NUMBER D2-14827

TITLE TECHNICAL FACILITY CRITERIA FOR THE MINUTEMAN LAUNCH
CONTROL FACILITIES, FRANCIS E. WARREN AFB, WYOMING (U)

Technical Revisions to Document D2-13798 (Revision A)

D2-14827
FIG.5-6
PAGE
13

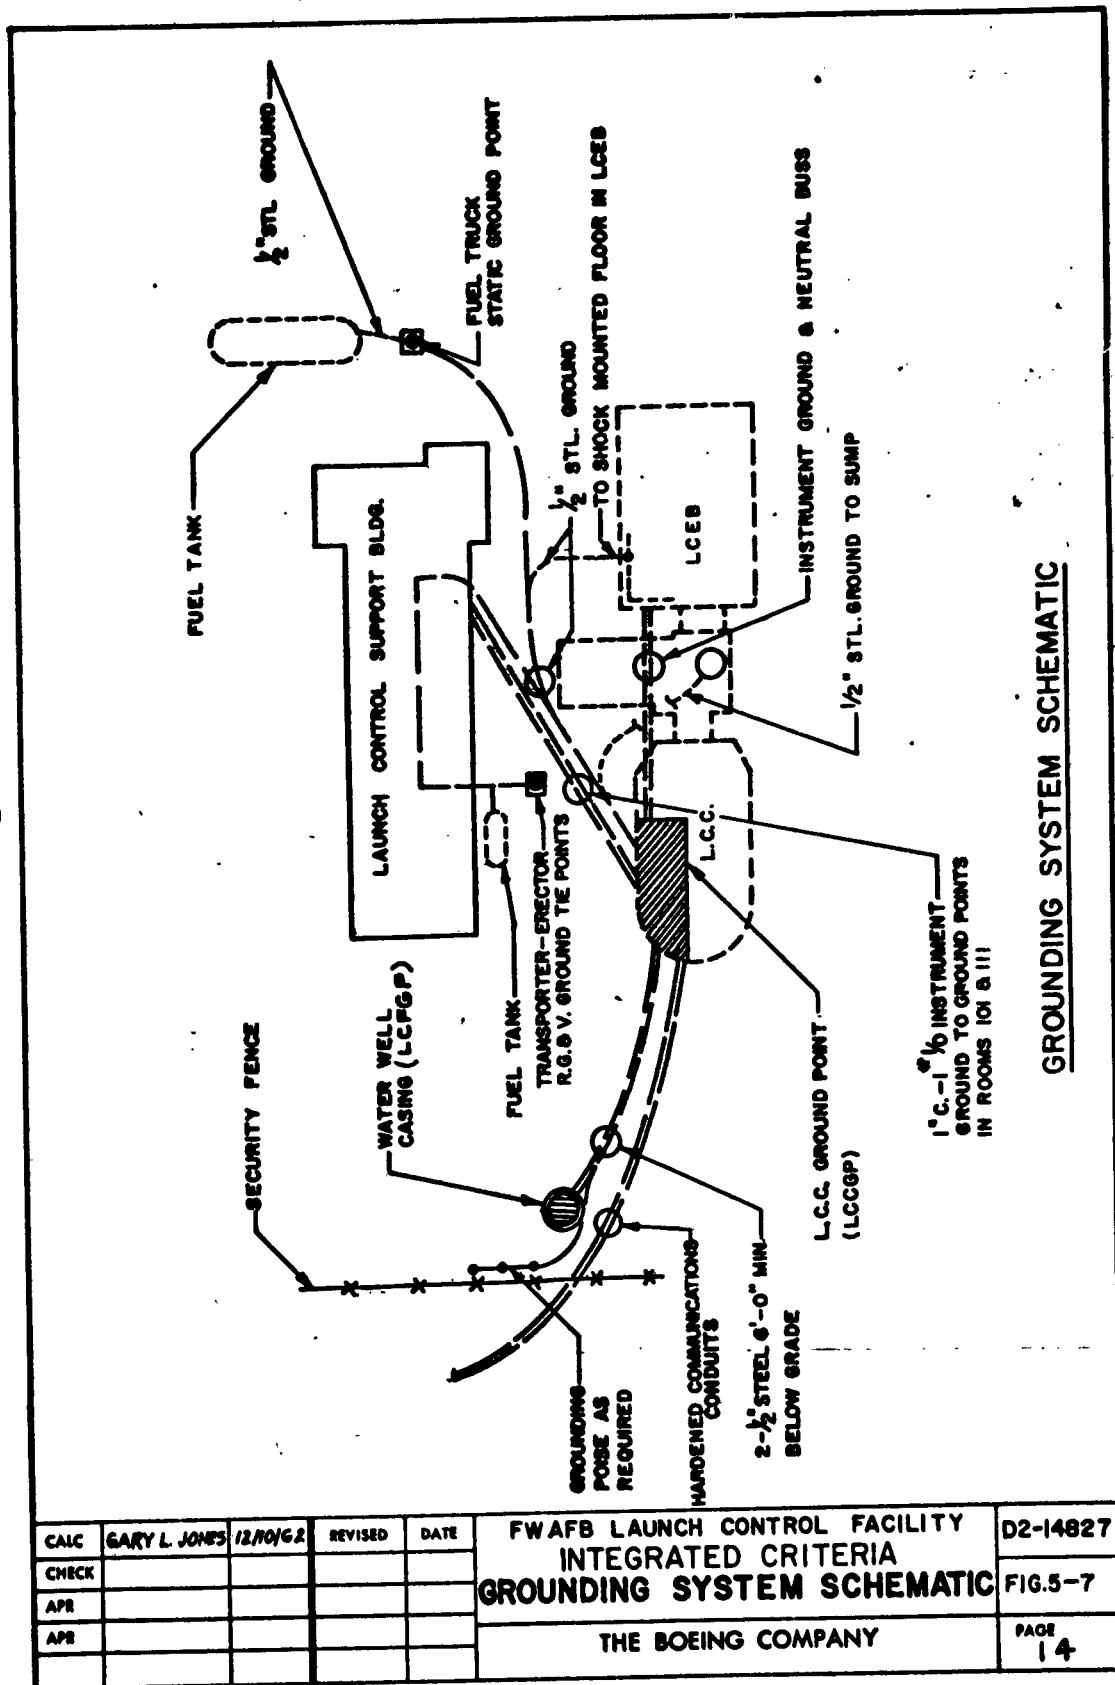
1. Figures 5-5, 5-6, 5-7, 5-8 and 5-8.1 revised per conduit changes.
2. Table 5-1 Equipment List LCF revised per LCEB equipment changes.

DATE	REVISED	BY	THE BOEING COMPANY	DS-14827
1967				FIG. 9-2
				SHOCK MOUNTED FLOOR DETAILS
				21

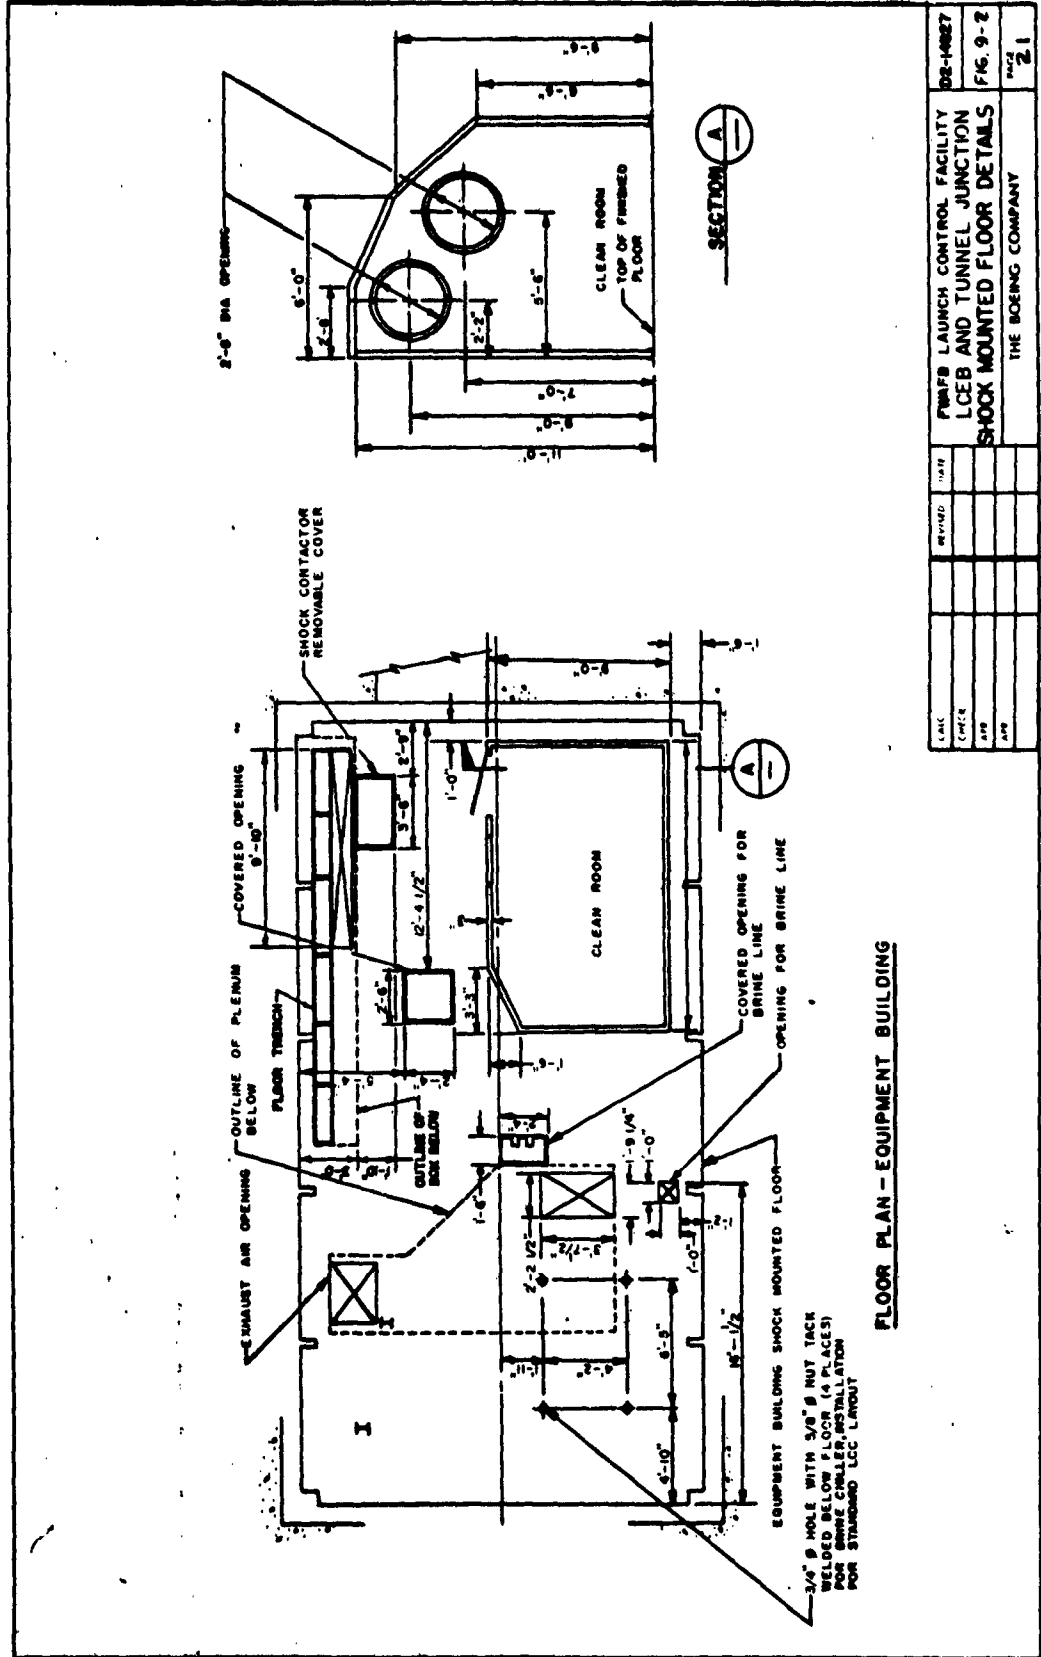
1. Figures 9-2, 9-3, 9-3.1, 9-3.2, 9-3.5, 9-3.6, 9-3.7, 9-4 and 9-7 revised per RPIE changes.
2. Figures 9-6 and 9-6.1 revised per blast valve changes.

22" BLAST VALVE REQUIREMENTS

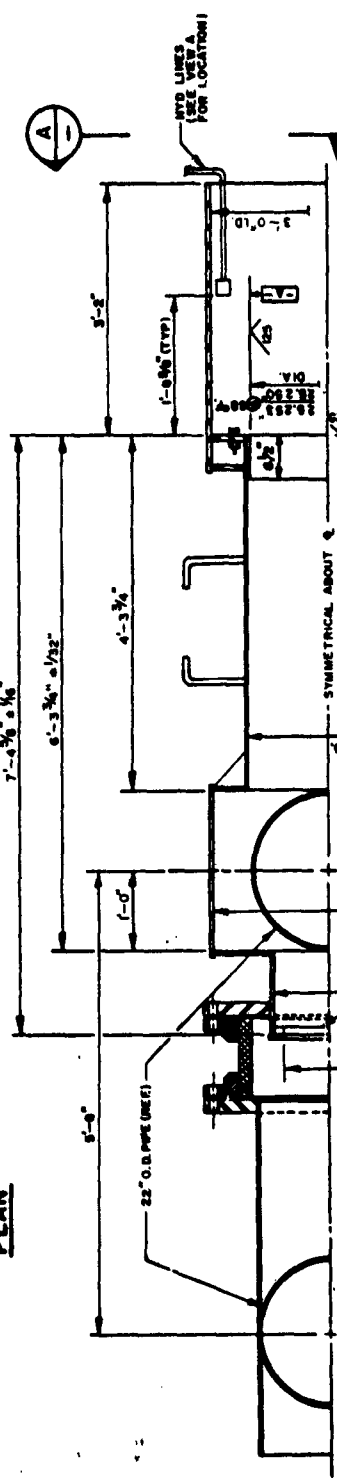
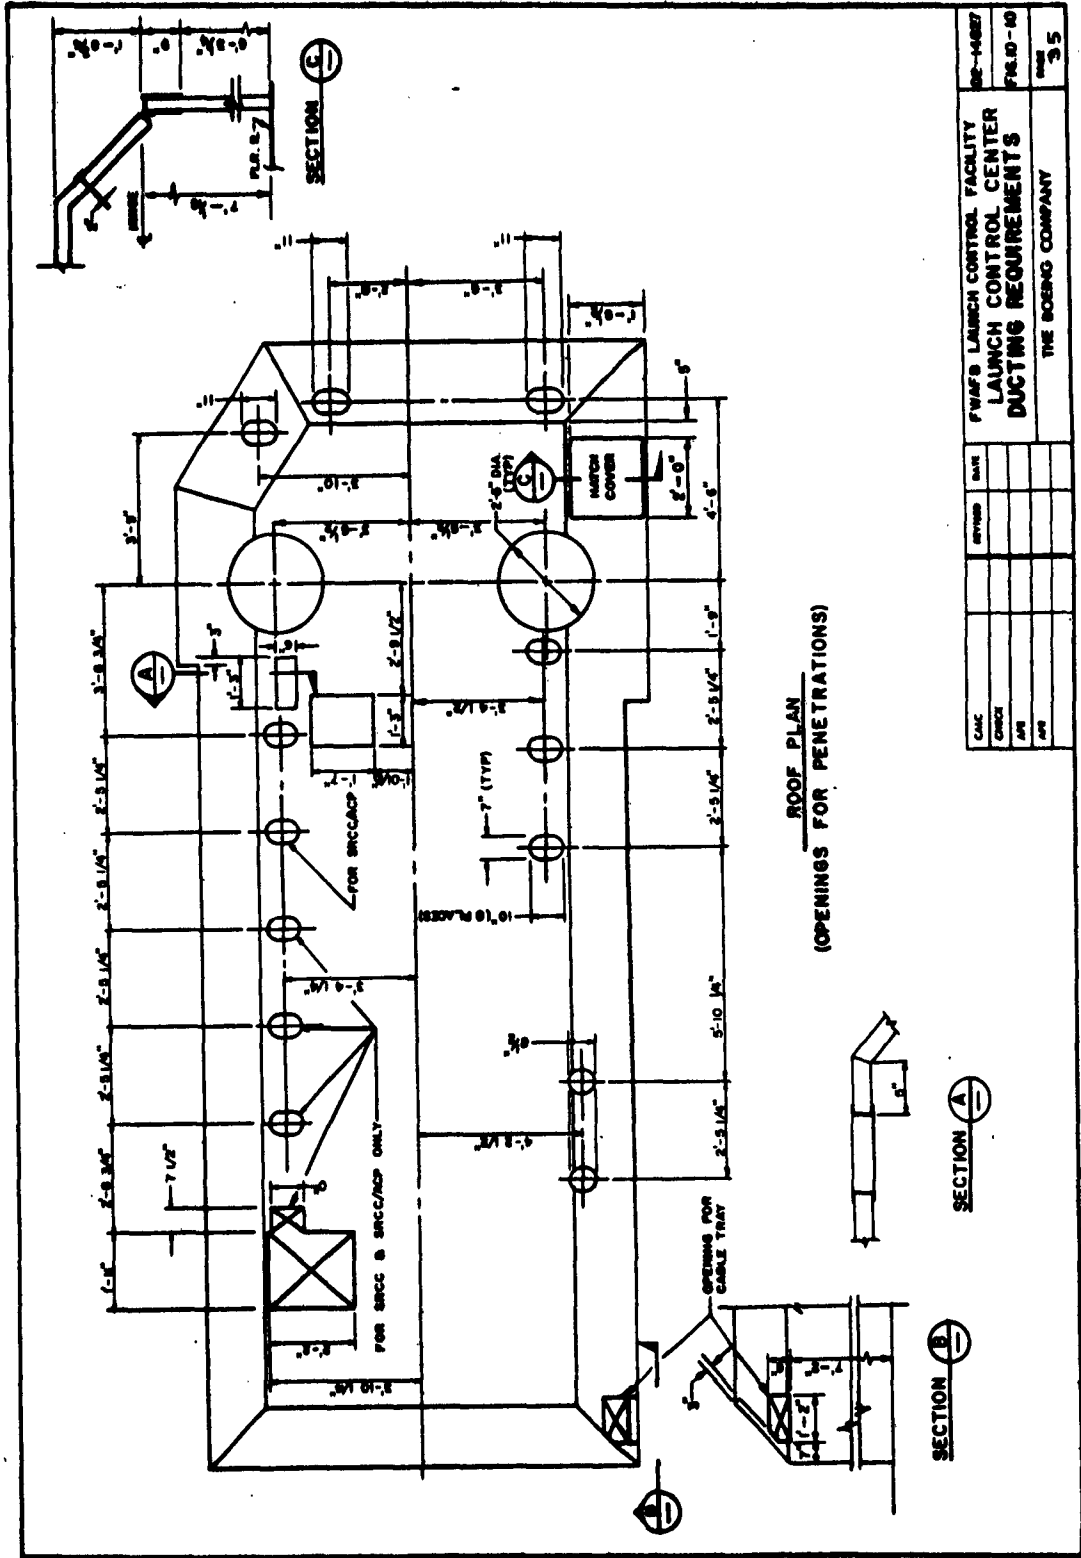
- 1. Figures 10-9 and 10-9.1 revised per blast valve changes.
- 2. Figure 10-10 revised to provide cable tray opening.
- 3. Figure 10-14.1 and 10-17 revised per conduit changes.
- 4. Figures 10-15 and 10-16.3 revised per cable tray changes.
